Scale
 167 L 1940 5 30

Series Plate No. 167 L
 Sheet 5 of 30

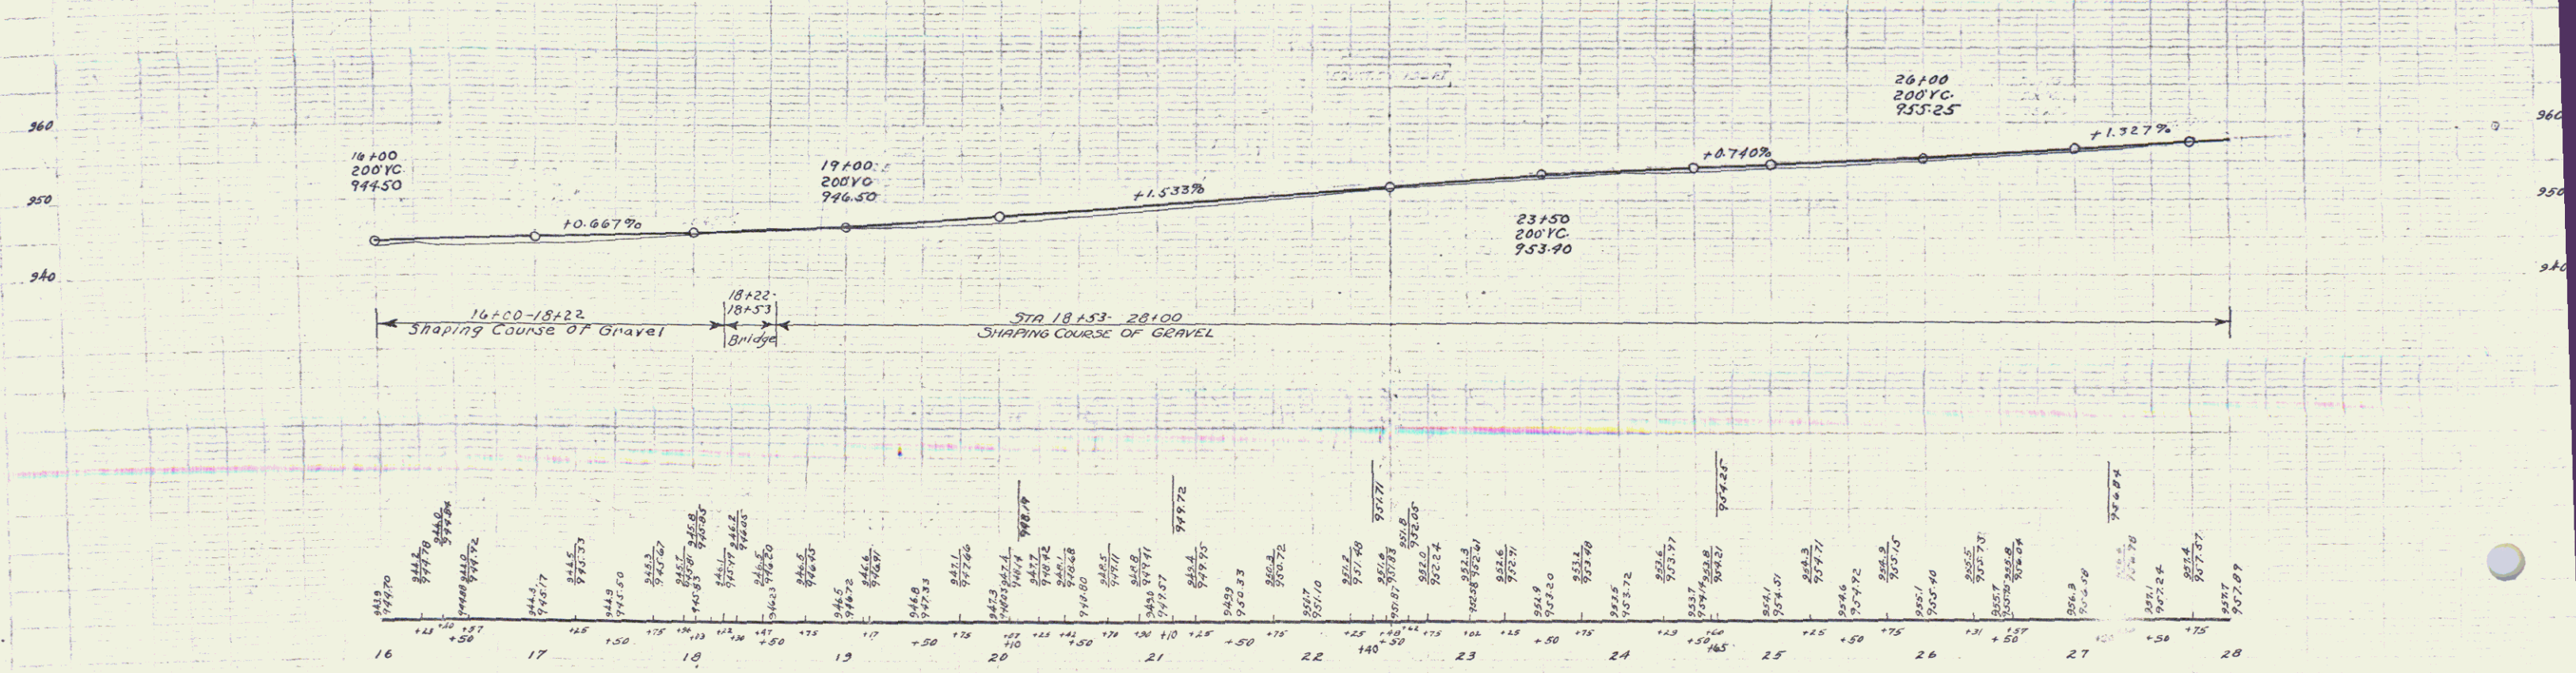
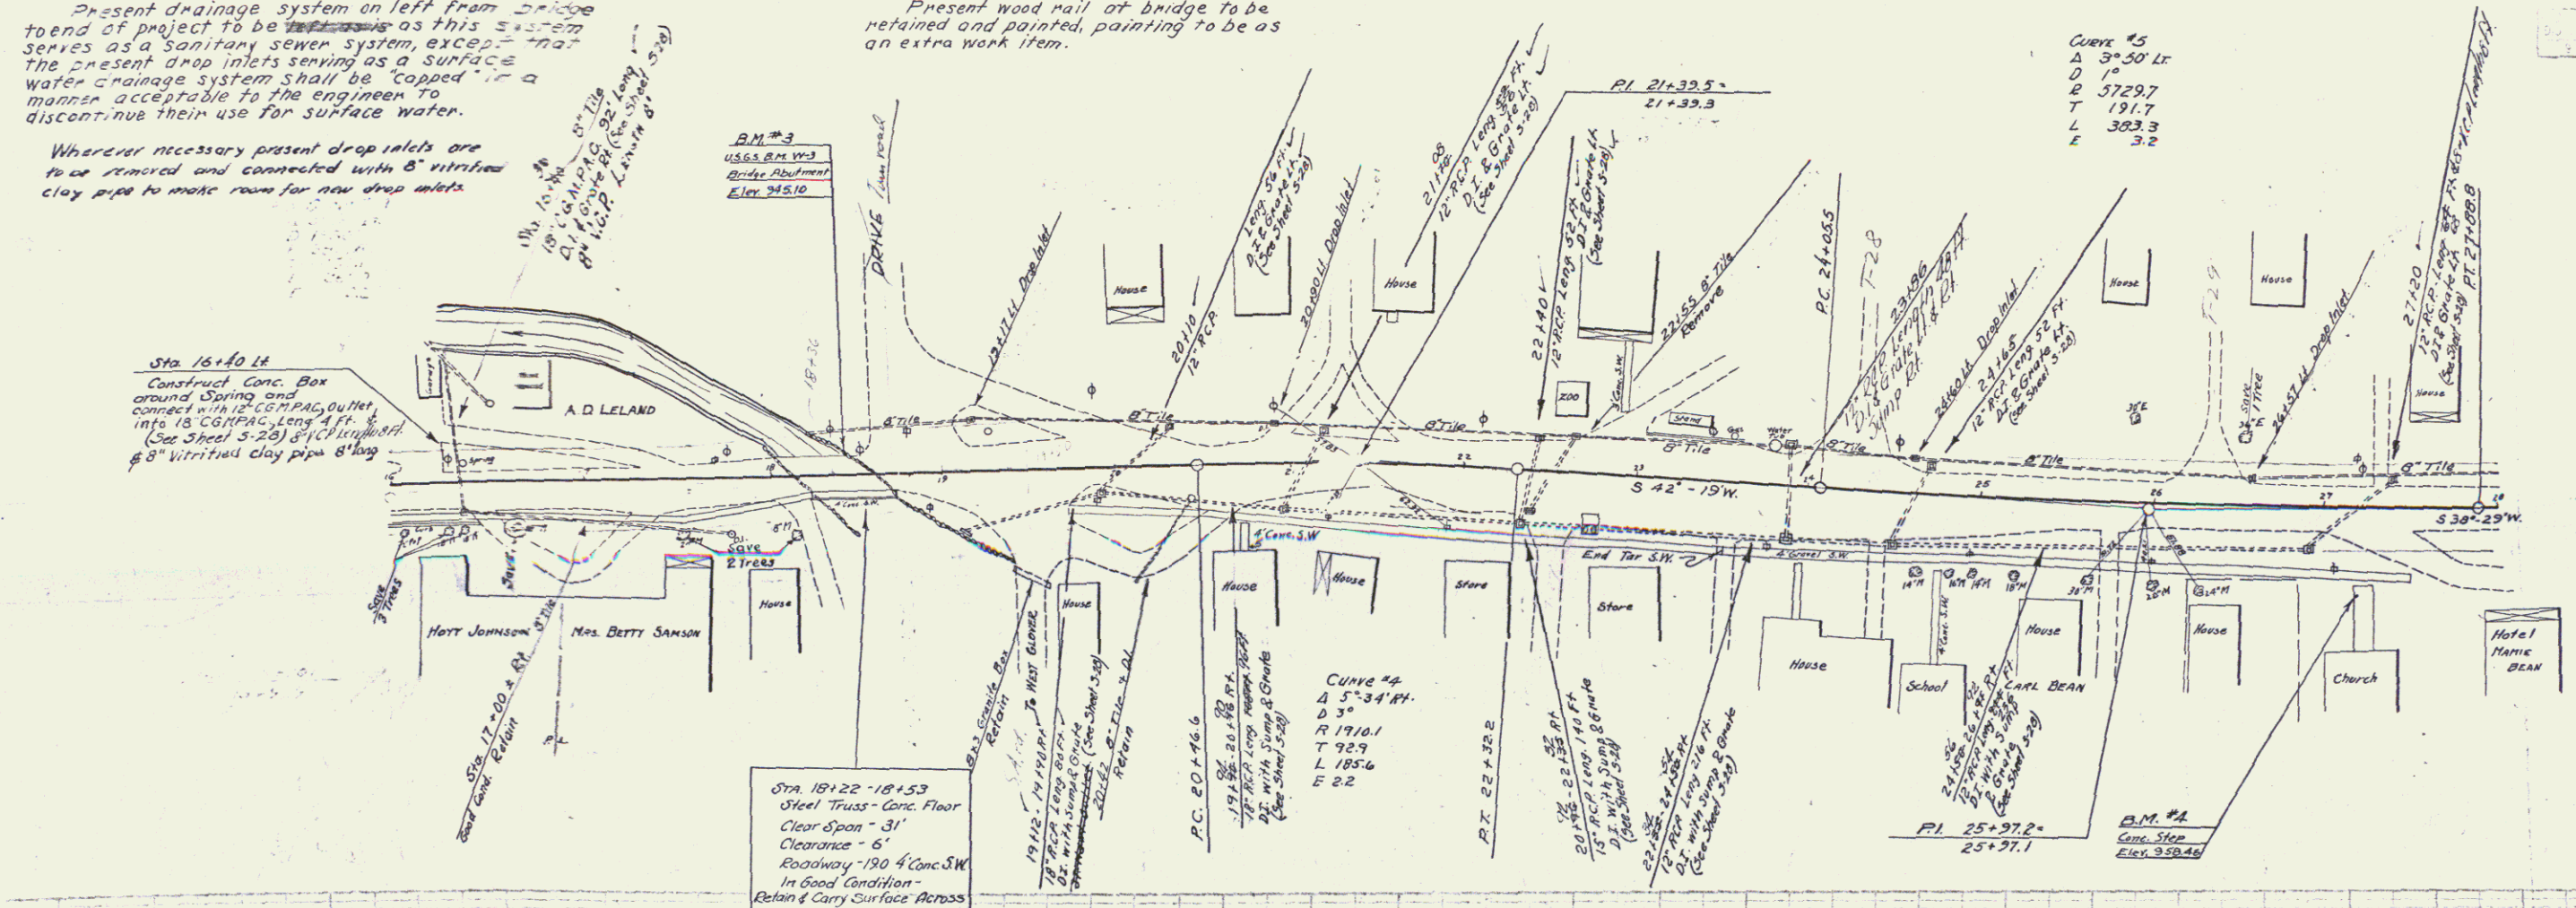
Present drainage system on left from bridge
 end of project to be ~~retained~~ as this system
 serves as a sanitary sewer system, except
 The present drop inlets serving as a surface
 water drainage system shall be "capped" in a
 manner acceptable to the engineer to
 discontinue their use for surface water.

Wherever necessary present drop inlets are
 to be removed and connected with 8" vitrified
 clay pipe to make room for new drop inlets.

Present wood rail of bridge to be
 retained and painted, painting to be as
 an extra work item.
